RESIDENTIAL DEVELOPMENT

8 Forest Road | Warriewood NSW 2102

SECTION 4.56(4) APPLICATION

SECTION 4.56 CHANGE LIST ADDENDUM (07/05/2024)

Drawing Title:
Elevations
Building A and B

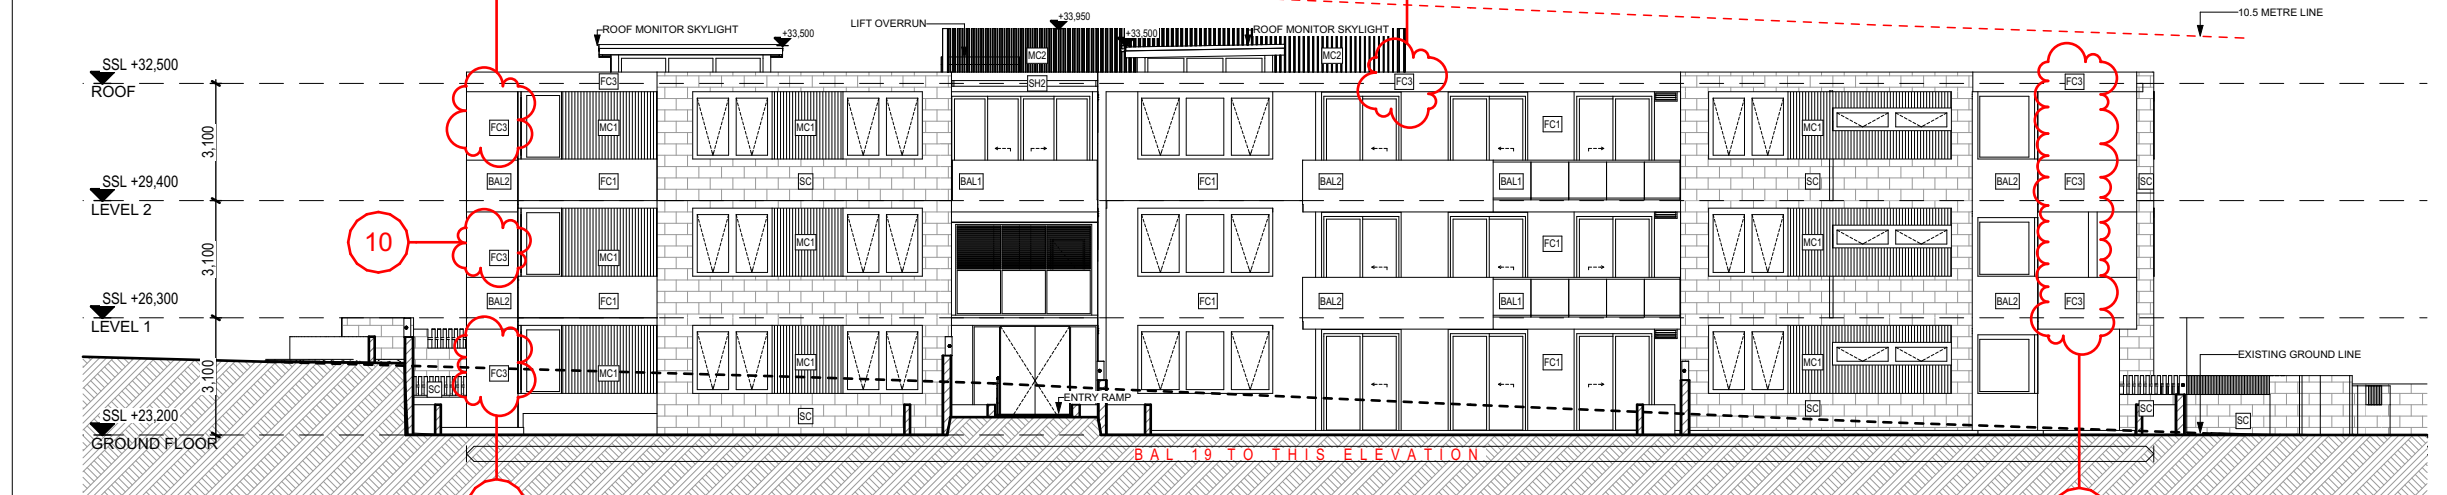
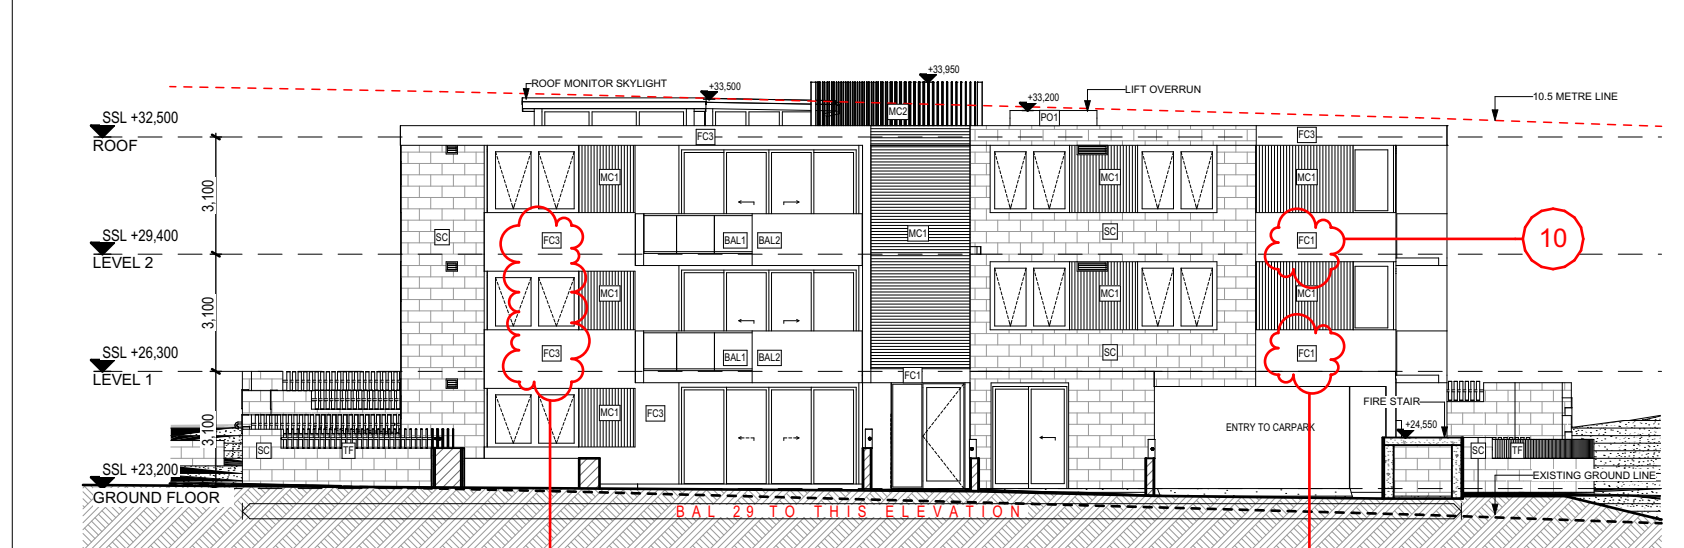
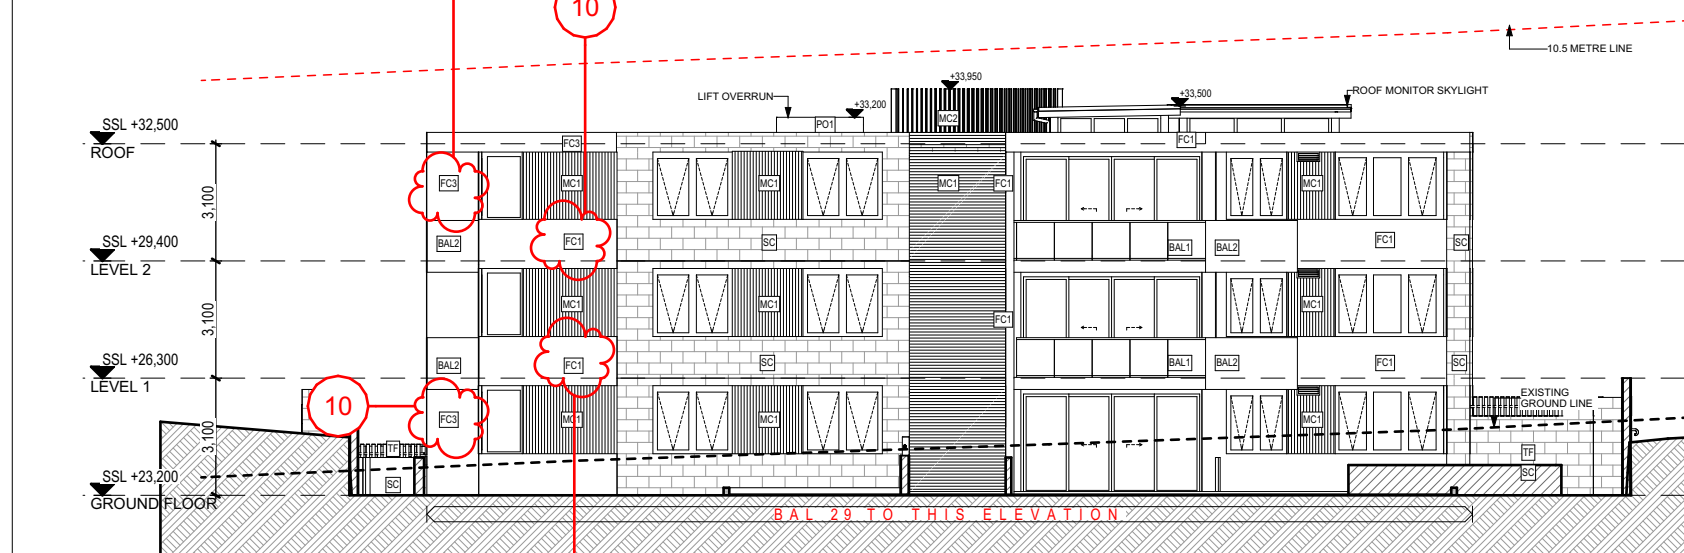
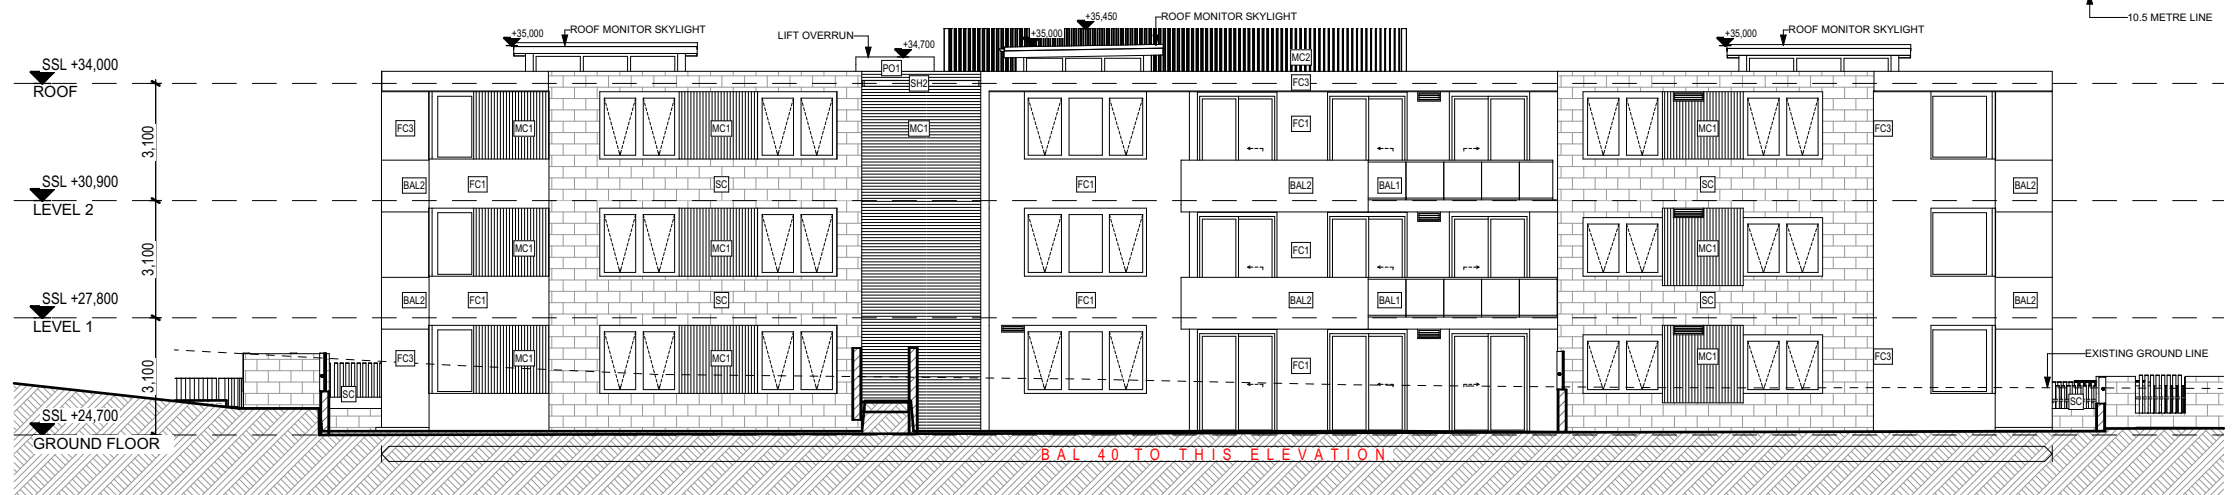
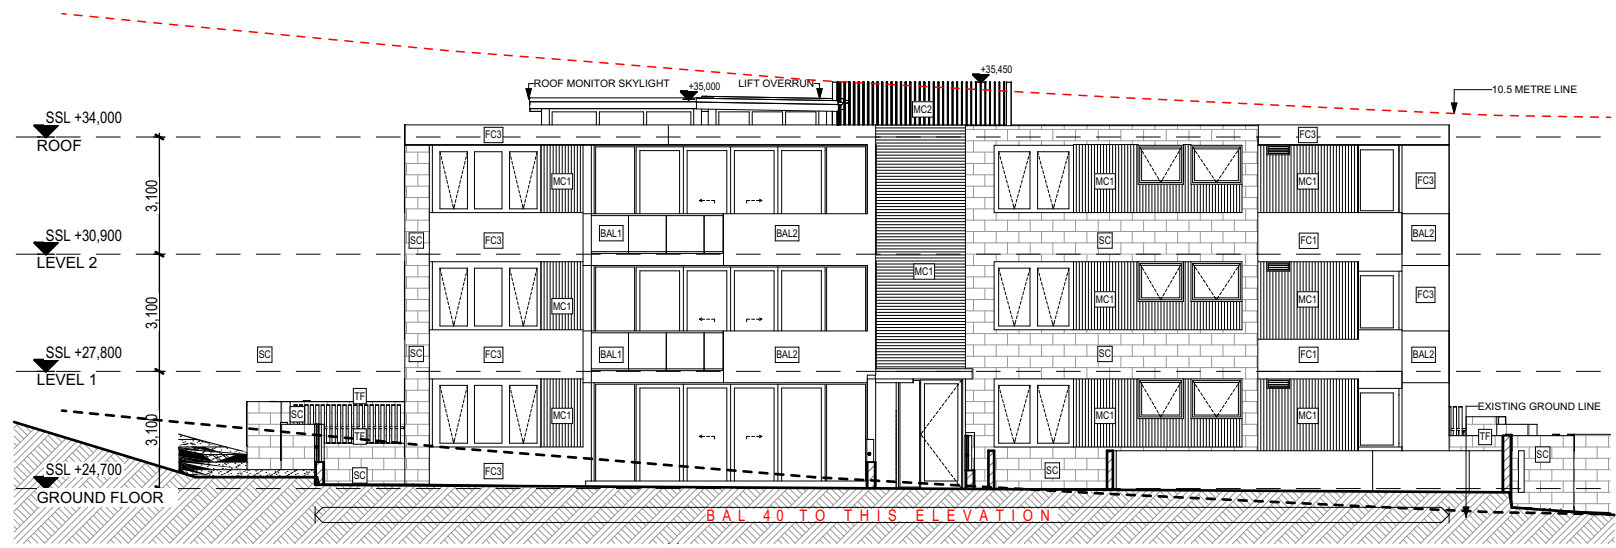
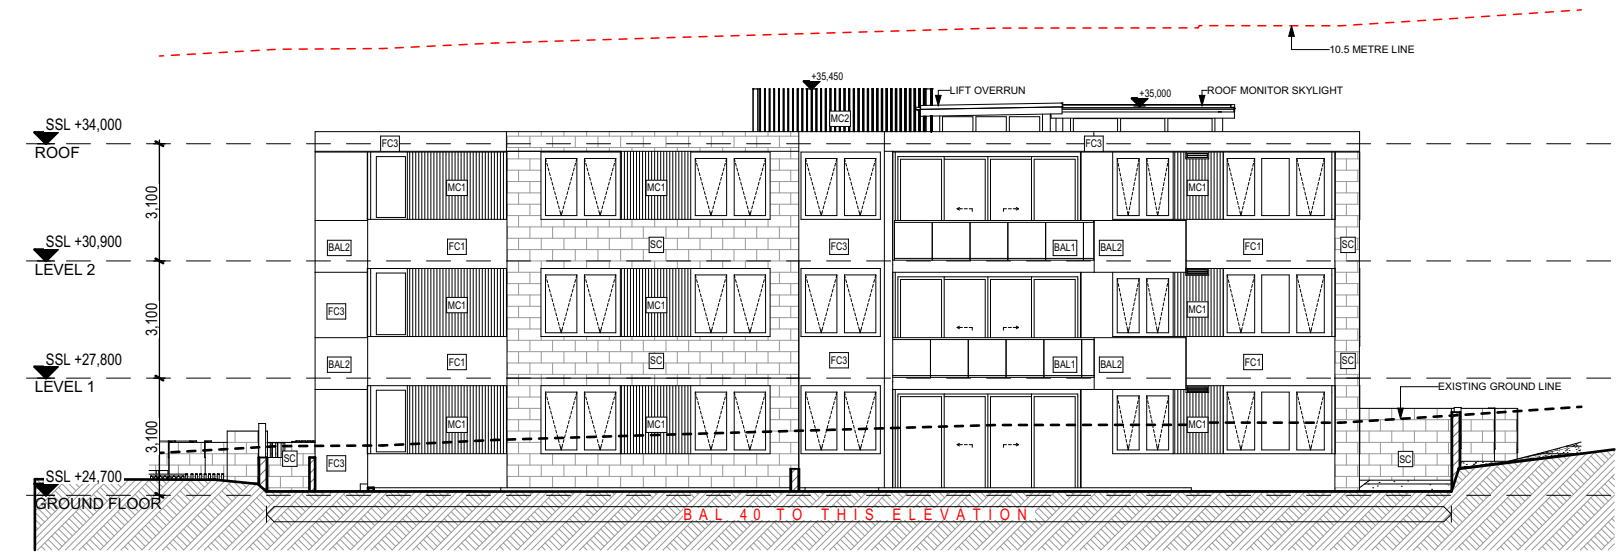
- INTERNAL FITOUT CHANGE INTO LIFT SPACE
 - LIFTS REMOVED FROM TOWNHOUSES 02, 03, 04, 05, 08, 09, 10, 11, 12, 13 & 14.
 - FINISH CHANGES, "TIMBER LOOK" CHANGED TO "DULUX DURALLOY ANOTEC MID BRONZE MATT" AND "SANDSTONE CLADDING" CHANGED TO "SANDSTONE LOOK"

- FACADE FINISH DRAFTING ERROR CORRECTIONS
 - LIFT OVERRUN REMOVED & ALLOWANCE FOR ROOF PARAPET ADDED, THE HEIGHT OF WHICH IS 100mm LOWER THAN THE PREVIOUSLY APPROVED LIFT OVERRUN HEIGHT.
